351-53 New South Head Rd
Double Bay NSW 2028

Demolition Plan

REV	DATE	AMENDMENT
B	4/7/19	Clarification for Council
C	26/11/19	Revised Development Application
D	22/3/21	Revised for Council meeting
E	24/5/21	Issue d for Section 34 conference
F	18/6/21	Section 34 conference progress update
G	14/7/21	Section 34 Agreement

DRAWING TITLE			
Ground Floor Plan			
JOB NO	DRAWN	SCALE	DRAWING NO.
18.41	AR/BD	1:200 @ A3	DA 2.102
DATE	CHECKED	PLOT DATE	REVISION
Sept. 18 PT		14/7/21	G

1 North Elevation
Scale: 1:200

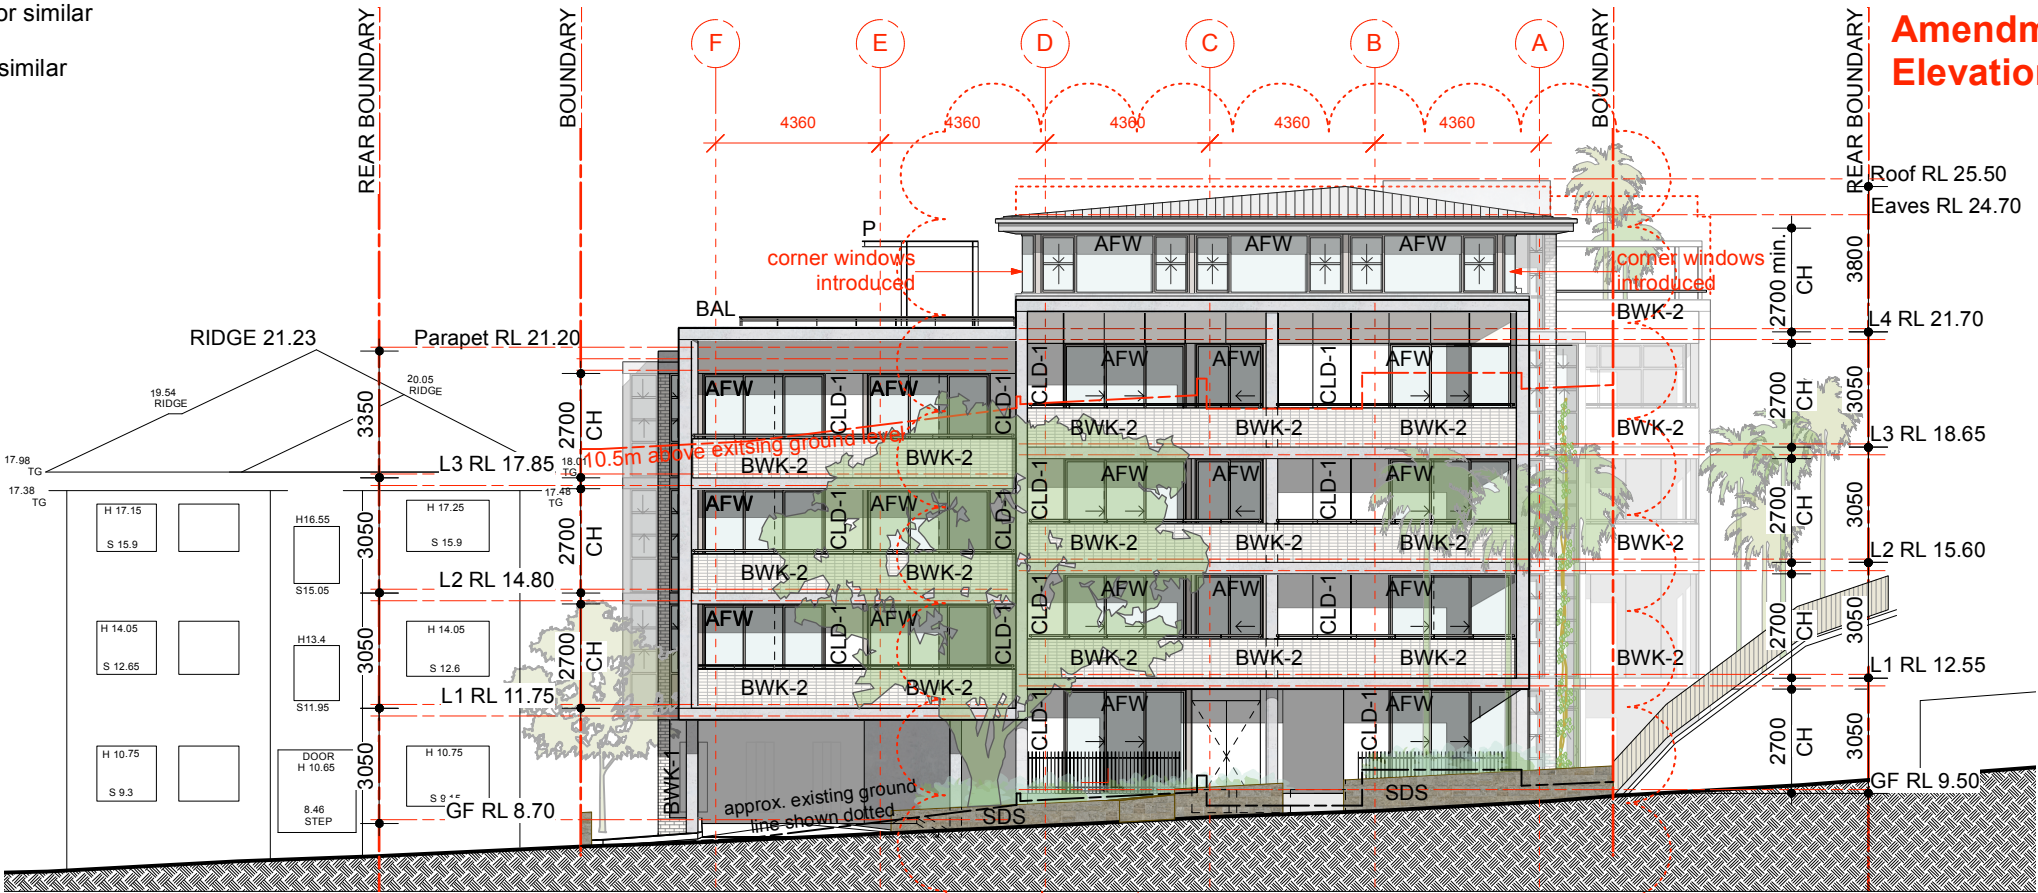
Amendments:
Elevation modified

1 East Elevation
Scale: 1:200

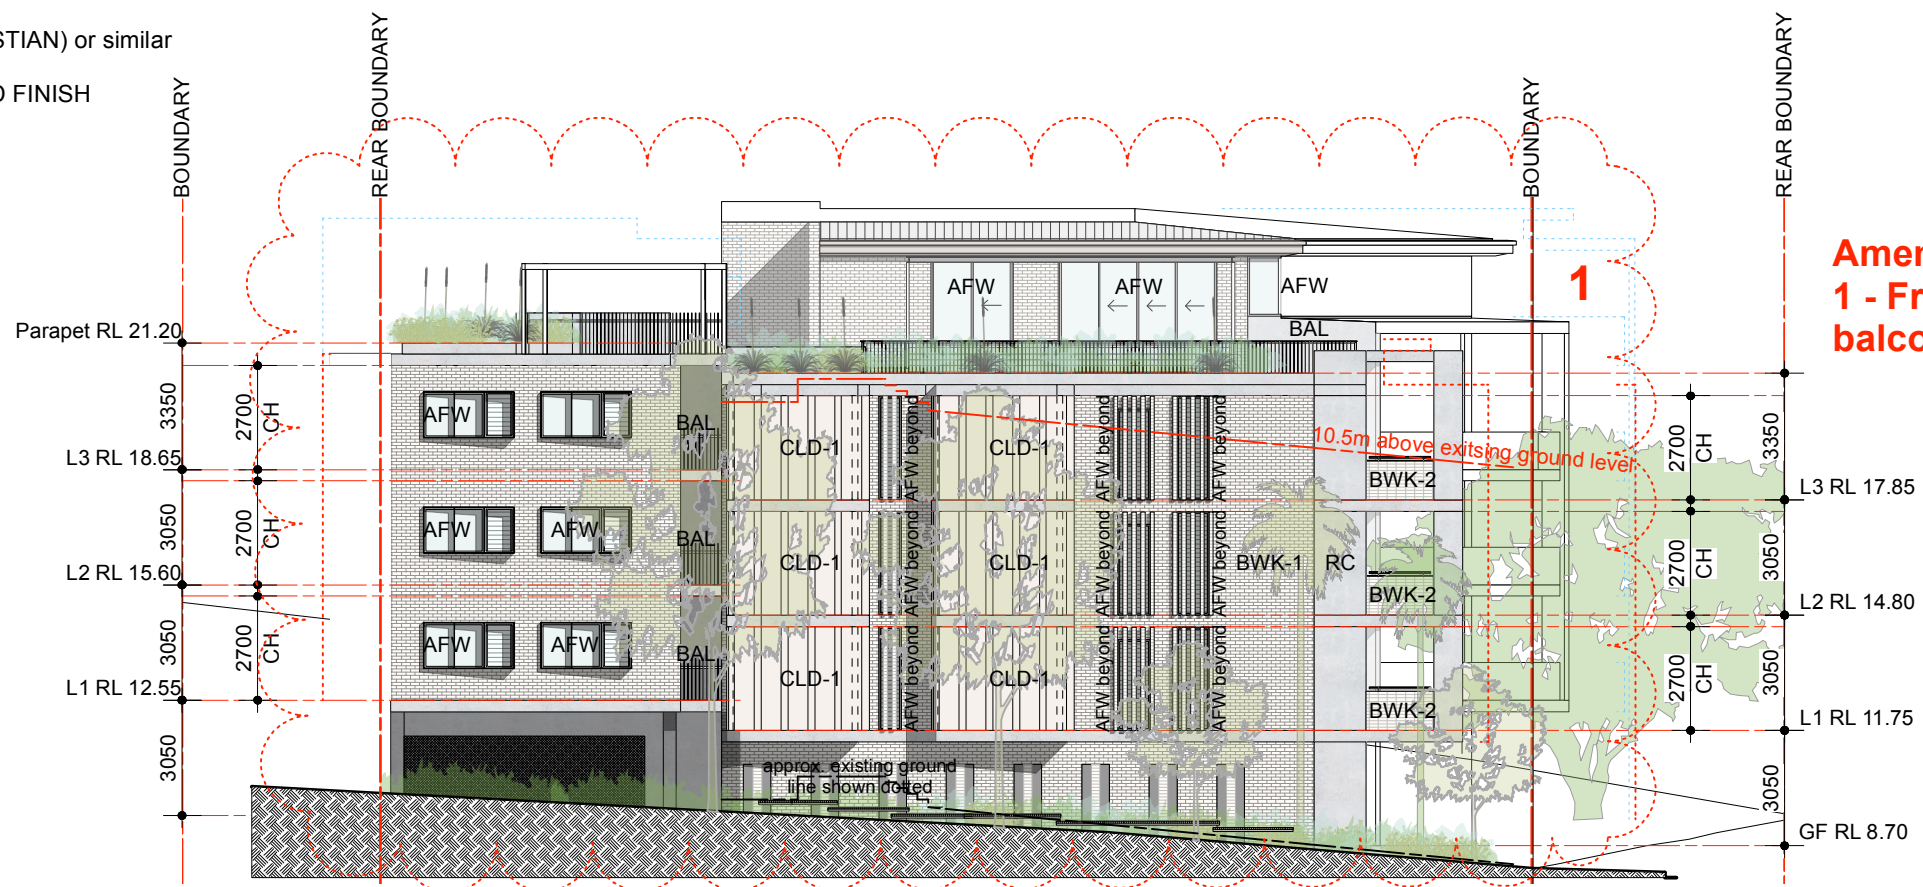
Amendments:
1 - Front setback increased,
balcony depth decreased

2 West Elevation
Scale: 1:200

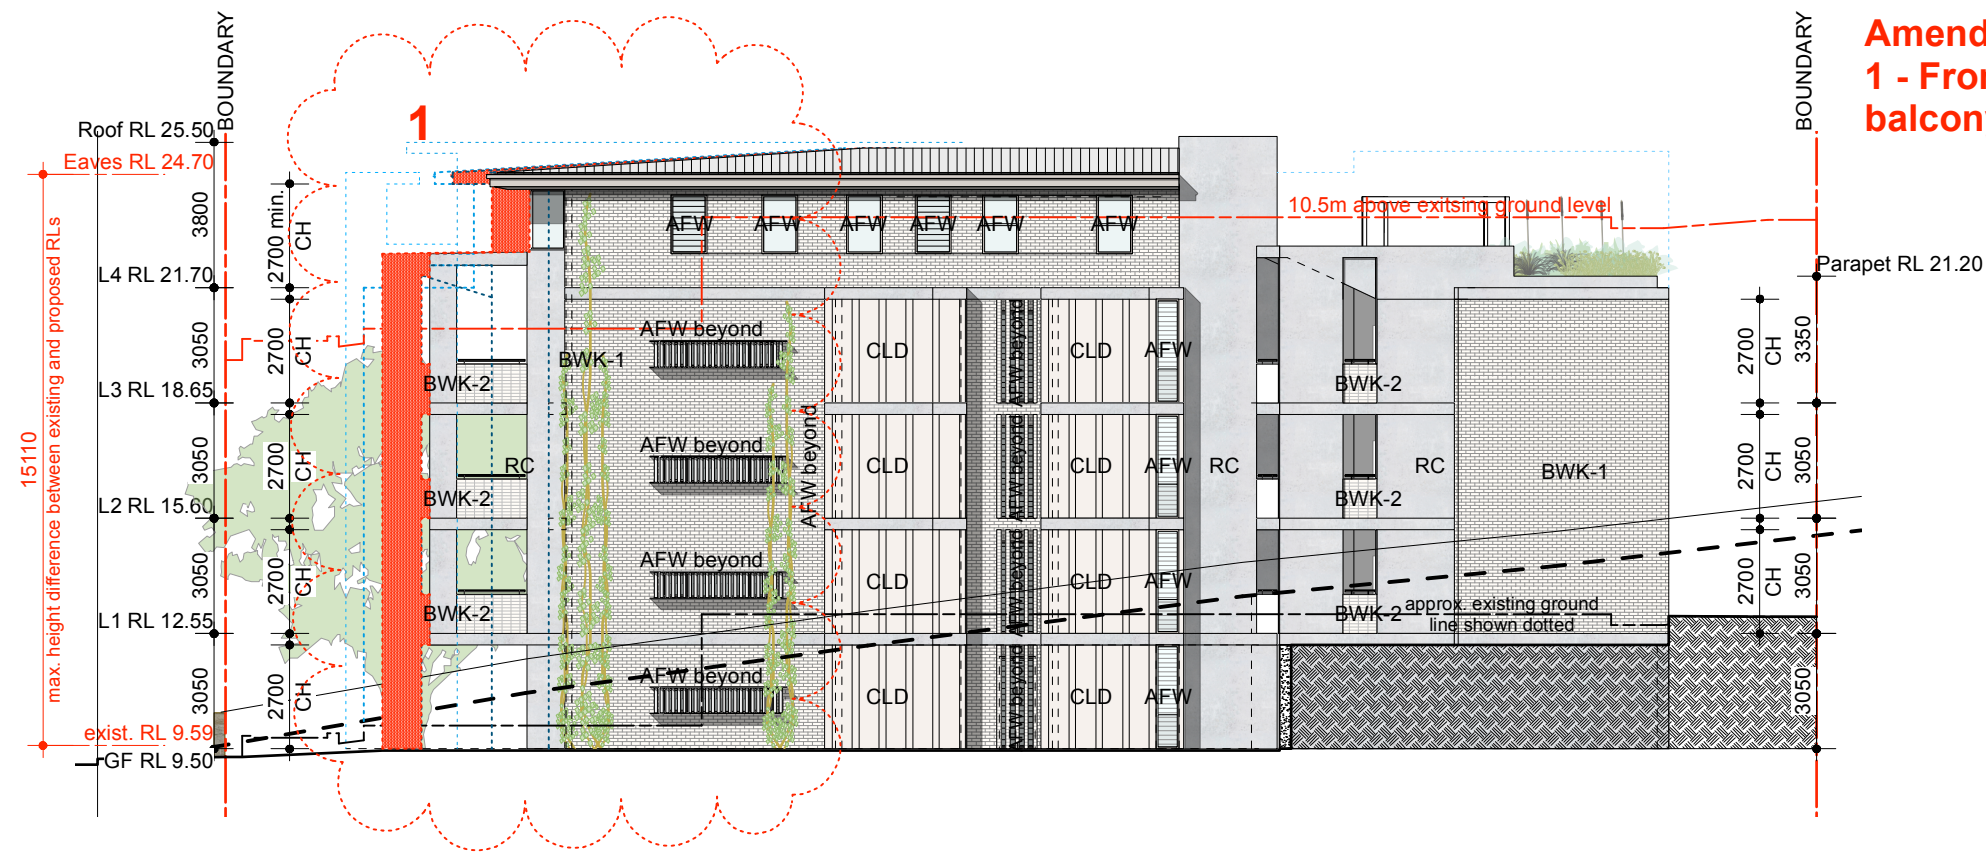
Amendments:
1 - Front setback increased,
balcony depth decreased
